AMENDMENTS TO THE DRAWING

REMARKS/ARGUMENTS

STATUS OF APPLICATION

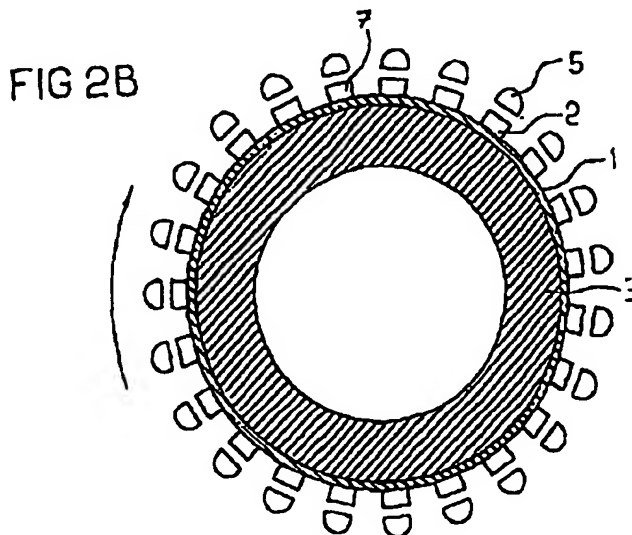
The embodiment of the present invention shown in FIG. 1A contains a printed circuit board 1 on which a plurality of preferably surface-mounted LEDs 2 are applied. In a known way, the printed circuit board 1 thereby forms a circuit that comprises terminal surfaces for the mounting of the LEDs at defined locations. These terminal surfaces are provided, for example, with lands for soldering in an automatic surface mount device (SMD) equipping unit, and the LEDs 2 have their electrical contacts 2a soldered to these terminal surfaces in a subsequent mounting step.

It is clearly evident that the printed circuit board is plastic or epoxy and is not a thermal conductor. This is explicitly stated at col. 3, lines 1-5

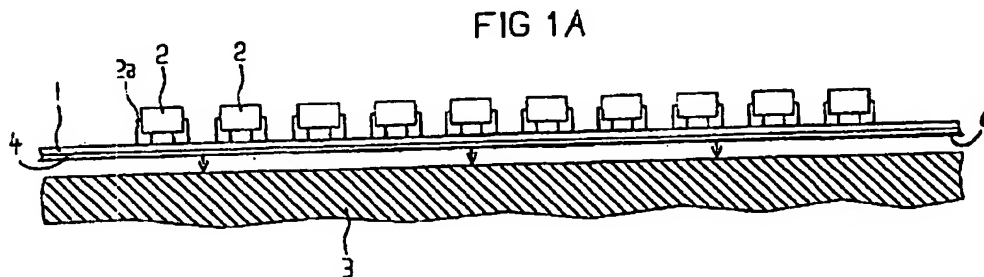
FIG. 2B does not show an elongate structure. The description of FIG. 2B fails to describe any structure that is clearly elongate. Similarly none of the drawings 1A, 2A, 2B, 2D show elongate members since they are all cross sections and as such show only at best a portion of one of the length or width of the member 3. FIG. 1B shows the only PC board 1 in its entirety and the structure is square not elongate. The squareness of the structure of FIG. 1B is easily determined by measuring the length and width of the structure. Little can be determined from the drawing of FIG. 2C since neither the drawing or description shows the cooling member or members 3.

In addition, the Examiner mischaracterizes the structure of FIG. 2B. The plain teachings of the reference clearly describe "3/1" as two separate elements and not as a unitary structure. The arrangement of "3/1" is shown and described more clearly in the alternate embodiment of FIG.1A.

It is clear from the descriptions of the structures of FIG.1A and 2B that **element 1 in all drawings is a plastic or epoxy electrically insulating and thermally insulating printed circuit board.** Element 3 is a thermally conductive member to which printed circuit board 1 is attached with an adhesive layer 6. Layer 4 is a metal layer on the back side of the printed circuit board 1.

It is clear from the drawings that the thermally conductive member 3 does not carry its LEDs 2 on its outer surface. **Rather, the thermally non-conductive printed circuit board 1 carries the LEDs 2.** The Examiner's attention is again directed to the reproduced portions of the reference above which clearly state that the LEDs are carried on the printed circuit board 1 and not on the structure 3.
